Access Compliance Report

Public Rights-of-Way

Intersection ID: 20624	Main Street: BRAMBLEWOOD_DR	Cross Street: W_ARROWWOOD_RD	Location: NE
ADA ID: F8079C9AB5B9	Ramp Type: PerpDiag	Initial Pass/Fail: Fail	Overall Compliance: No
		Severity Score: 12.5

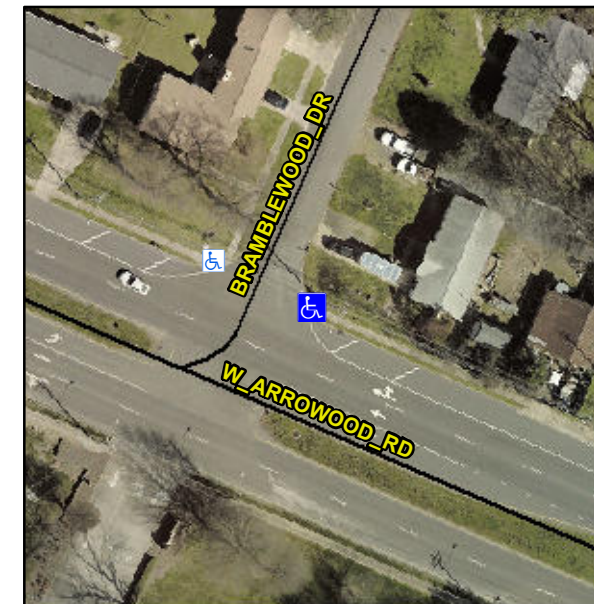
Not Found, R304.2.2

Compliance	Description	Data	Compliance	Description	Data
N/A	Ramp Length (in)	32.0	No	Ramp Slope (%)	9.1
Yes	Ramp Width (in)	48.0	Yes	Ramp XSlope (%)	1.2
N/A	Flare Type LT	N/A	N/A	Flare Type RT	N/A
N/A	Flare Slope LT (%)	N/A	N/A	Flare Slope RT (%)	N/A
N/A	Flare Traversable LT?	N/A	N/A	Flare Traversable RT?	N/A
N/A	Landing Length (in)	N/A	N/A	DWS Provided?	N/A
N/A	Landing Width (in)	N/A	N/A	DWS Contrast?	N/A
N/A	Landing Slope (%)	N/A	N/A	DWS Length (in)	N/A
N/A	Landing X Slope (%)	N/A	N/A	DWS Full Width?	N/A
N/A	Landing Curb? (Y/N)	N/A	N/A	DWS Offset (in)	N/A
N/A	Shared Landing?	N/A			
N/A	Gutter Ponding?	N/A	N/A	Gutter Slope (%)	N/A
N/A	Gutter Lip Ht (in)	N/A	N/A	Gutter X Slope (%)	N/A
N/A	Painted X Walk1?	No	N/A	Painted X Walk2?	No
	X Walk 1 Direction	To NW		X Walk 2 Direction	To SW
N/A	X Walk 1 Width (in)	N/A	N/A	X Walk 2 Width (in)	N/A
	X Walk 1 Slope (%)	1.2		X Walk 2 Slope (%)	4.7
	X Walk 1 X Slope (%)	1.8		X Walk 2 X Slope (%)	0.2

Remove & Replace Curb Ramp With Two New Directional Ramps or Equivalent.
